**RE: ADDENDUM #11 TO THE COMSTOCK MINING INC., CARSON RIVER MERCURY SUPERFUND SITE SAMPLING AND ANALYSIS PLAN**

On behalf of Comstock Mining Inc. (Comstock), McGinley and Associates (MGA) is providing this Addendum #11 for the Lot 51 area as shown on the attached Figure 1.

**Addendum #11 - LOT 51**

**Comstock Mining, Inc.**  
**CRMS Sample & Analysis Plan**

DRAWING NO. **Figure 1** REVISION NO. **A**

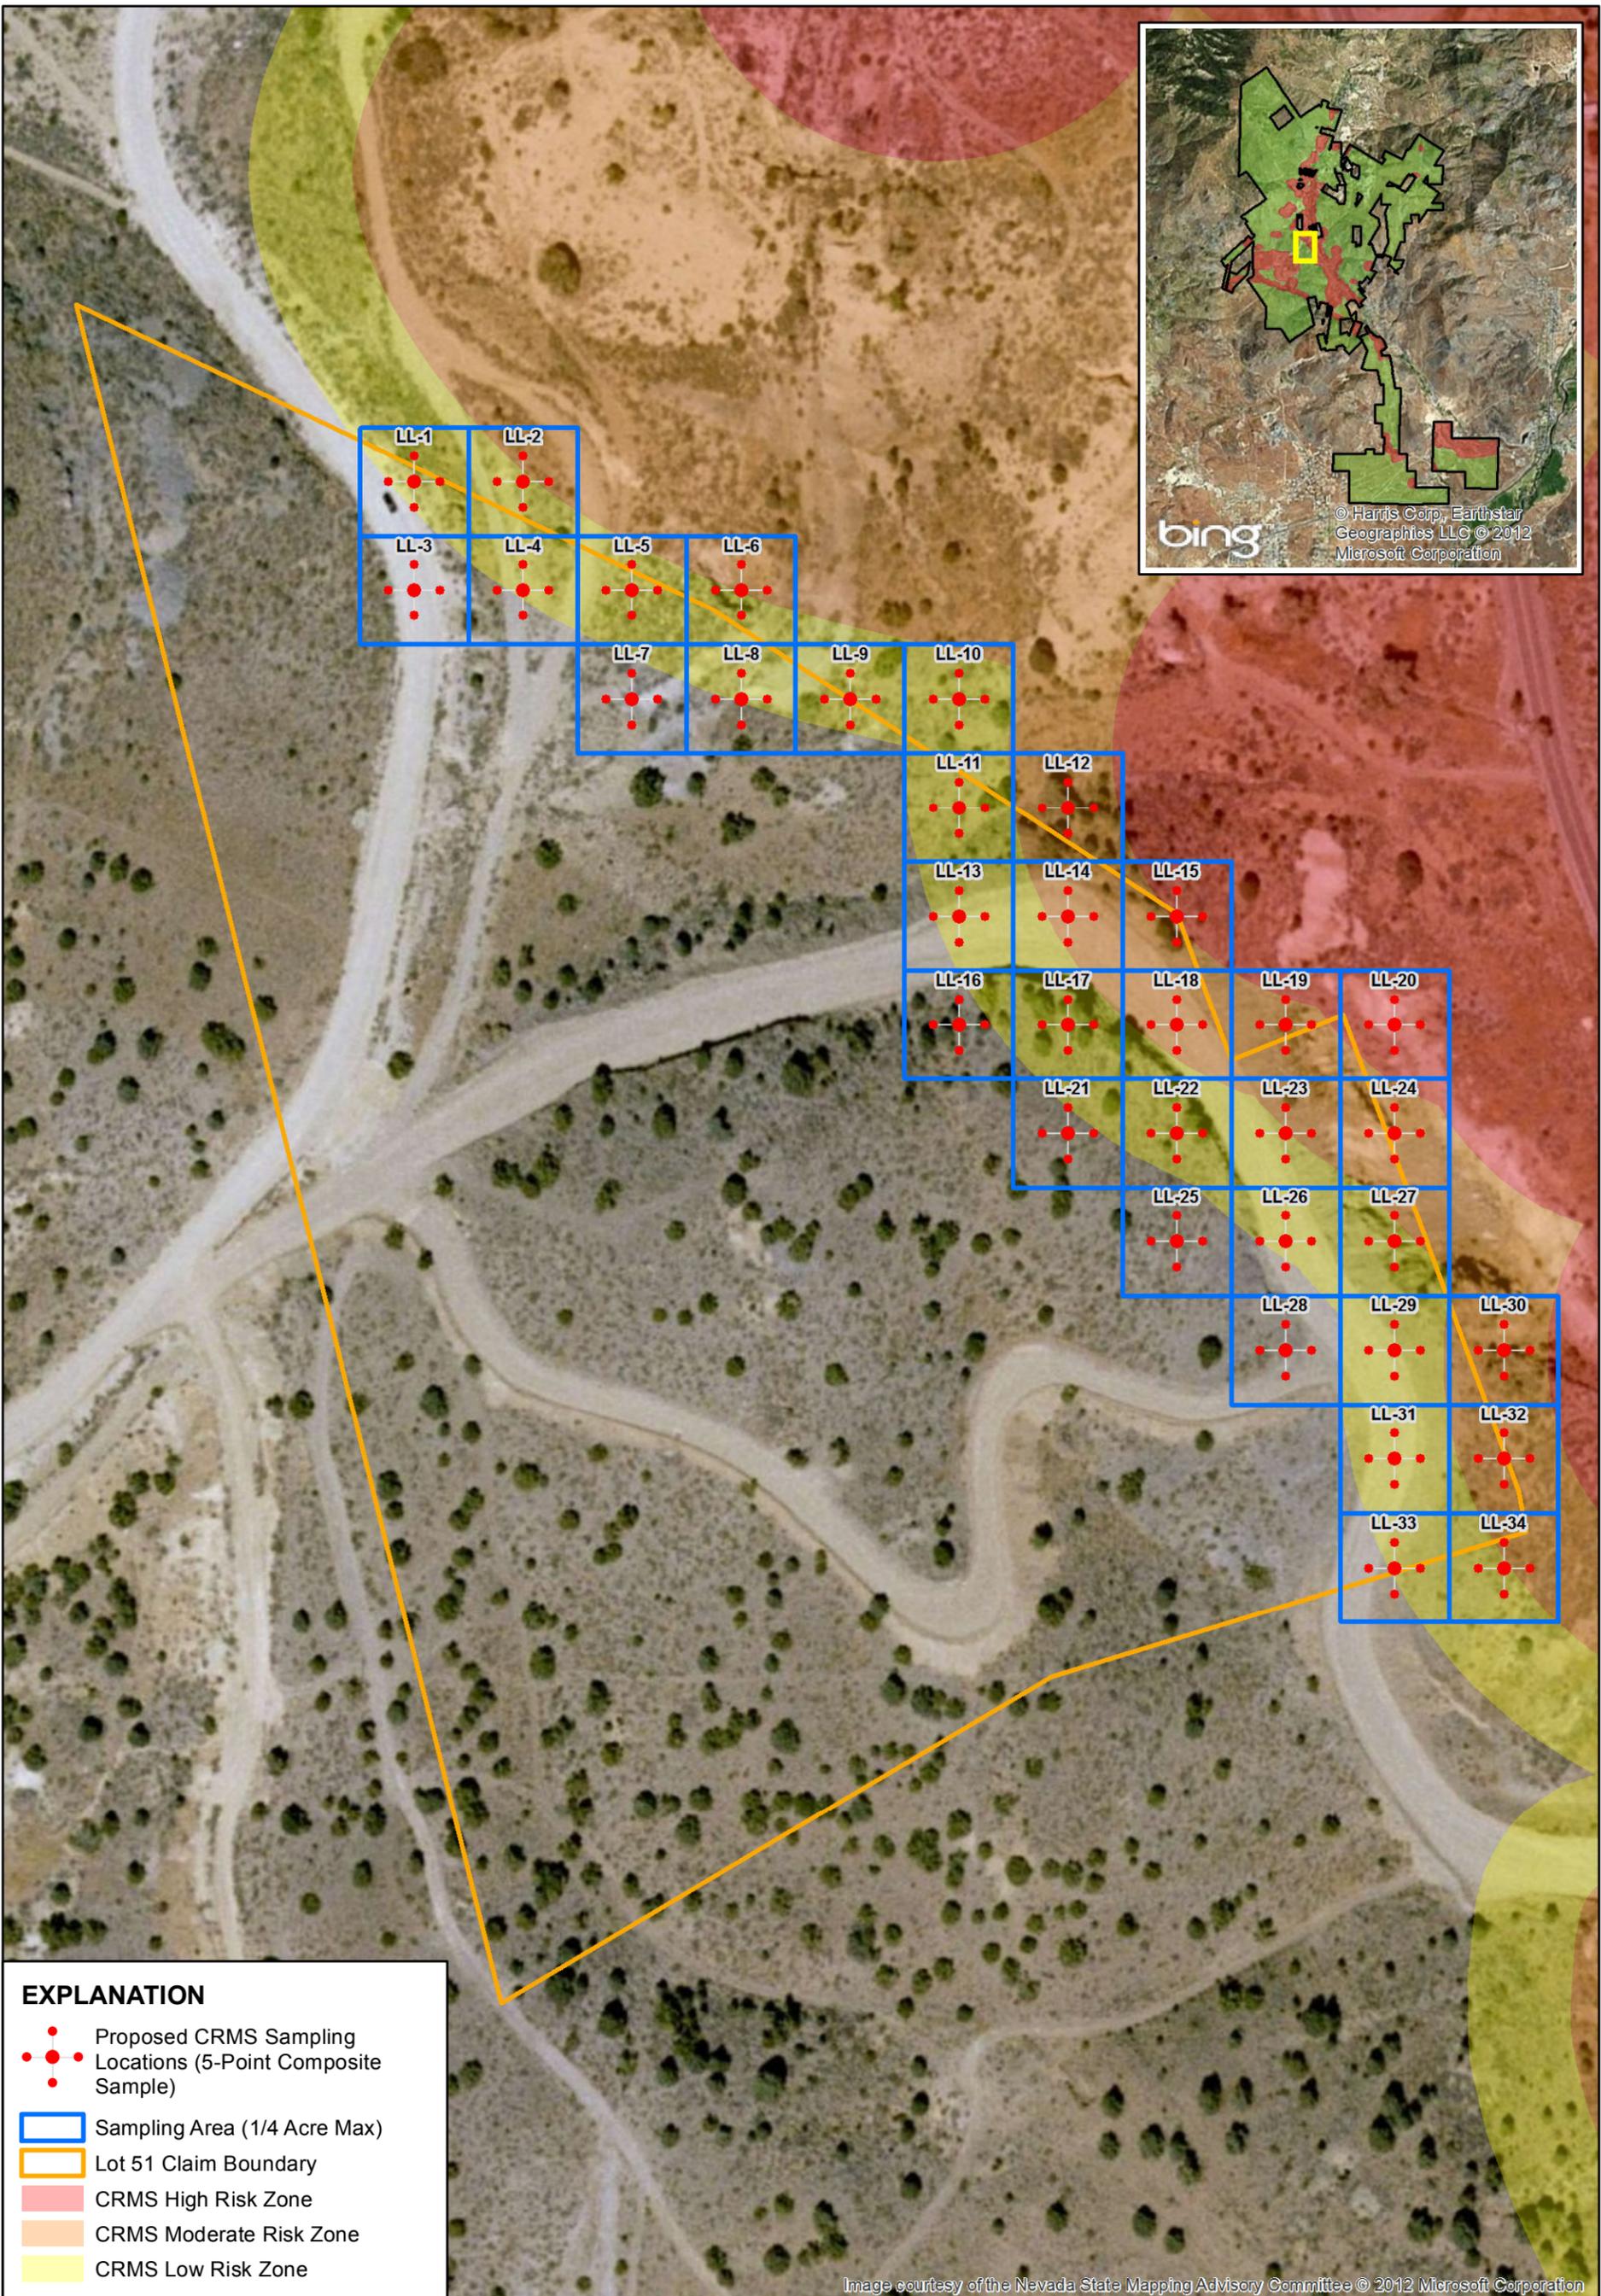
Comstock proposes to install 136 5-point composite samples at 34 locations as shown on the attached Figure 1. This includes 34 ¼ acre quadrants. These samples will be installed from 0-2' below ground surface (bgs) with samples taken at 0-6", 6-12", 12-18" and 18-24" bgs consistent with previous sampling efforts.

The sampling density proposed is that which is outlined in Section 4.0, item 2 of the NDEP-approved Sampling and Analysis Plan (SAP). The sampling of the open land space is described in Section 4.0, items 2.a.
